Roth Engineering, LLC

Re: **Runnymede Gardens – Cam Gar at Verona LLC**
Block 2303, Lot 1
Township of Verona, Essex County, NJ
Roth Engineering Project # 201006

We are hereby submitting this response letter to address the review comments for the above noted project. As you are aware, the July 8, 2021 Zoning Board of Adjustment meeting did not take place and this application is anticipated to be heard at the August 12, 2021 meeting. We are sending a digital version of this letter with enclosures directly to the Construction Official, Board Engineer, and Chairperson of the Environmental Commission via email. We have enclosed the below additional information to support our responses:

Our specific responses to the review comments are as follows:

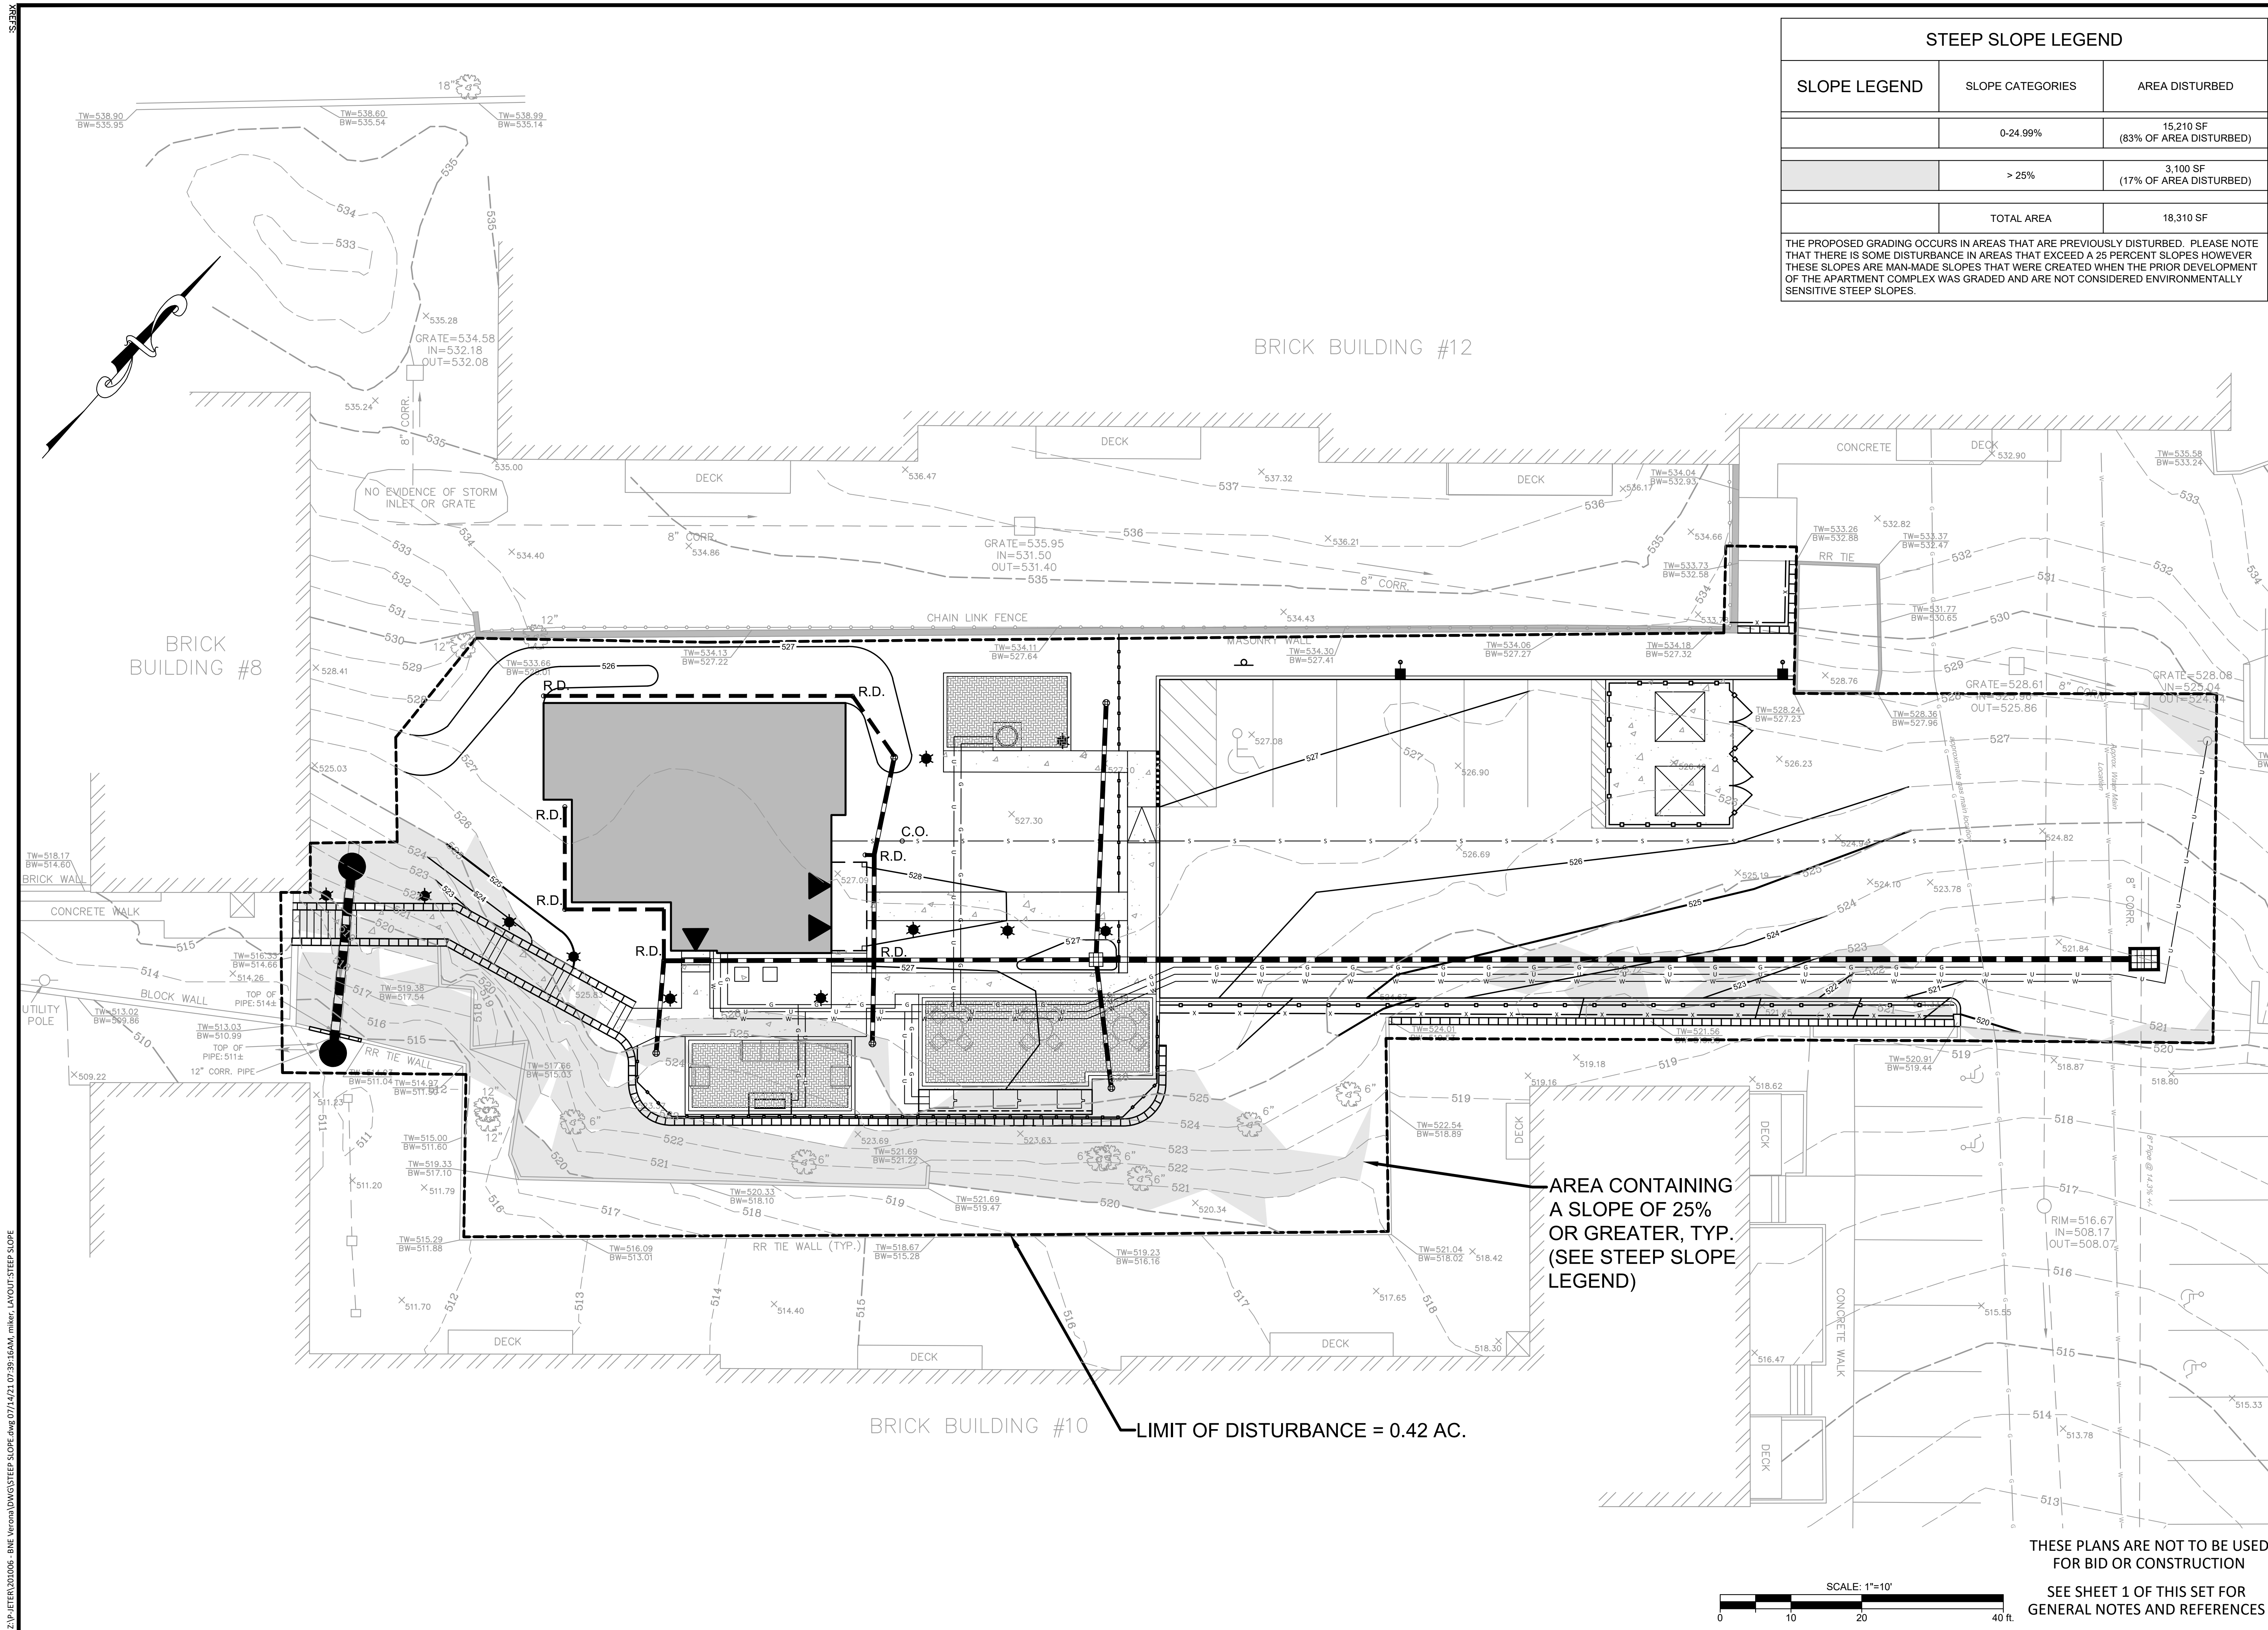
1. The project proposes disturbance on a small portion of steep slope areas (slope equal to or greater than 25 percent) however those slopes are man-made slopes that were created at the time of the construction of the development and are not environmentally sensitive steep slopes. A steep slope analysis is included in this resubmission package.
2. No response required.
3. The construction drawings will depict the various site furnishings. It is undetermined at this time if the tables and chairs will be fixed.
4. The construction drawings will depict the paver detail.
5. Pervious pavers are not proposed at this time.
6. Retaining walls forty-eight inches or higher will be submitted for a construction permit with signed and sealed engineered drawings.

29. No response required.
30. The project proposes disturbance on a small portion of steep slope areas (slope equal to or greater than 25 percent) however those slopes are man-made slopes that were created at the time of the construction of the development and are not environmentally sensitive steep slopes. A steep slope analysis is included in this resubmission package.

6. The project proposes disturbance on a small portion of steep slope areas (slope equal to or greater than 25 percent) however those slopes are man-made slopes that were created at the time of the construction of the development and are not environmentally sensitive steep slopes. A steep slope analysis is included in this resubmission package.

STEEP SLOPE LEGEND		
SLOPE LEGEND	SLOPE CATEGORIES	AREA DISTURBED
	0-24.99%	15,210 SF (83% OF AREA DISTURBED)
	> 25%	3,100 SF (17% OF AREA DISTURBED)
	TOTAL AREA	18,310 SF

THE PROPOSED GRADING OCCURS IN AREAS THAT ARE PREVIOUSLY DISTURBED. PLEASE NOTE THAT THERE IS SOME DISTURBANCE IN AREAS THAT EXCEED A 25 PERCENT SLOPES HOWEVER THESE SLOPES ARE MAN-MADE SLOPES THAT WERE CREATED WHEN THE PRIOR DEVELOPMENT OF THE APARTMENT COMPLEX WAS GRADED AND ARE NOT CONSIDERED ENVIRONMENTALLY SENSITIVE STEEP SLOPES.
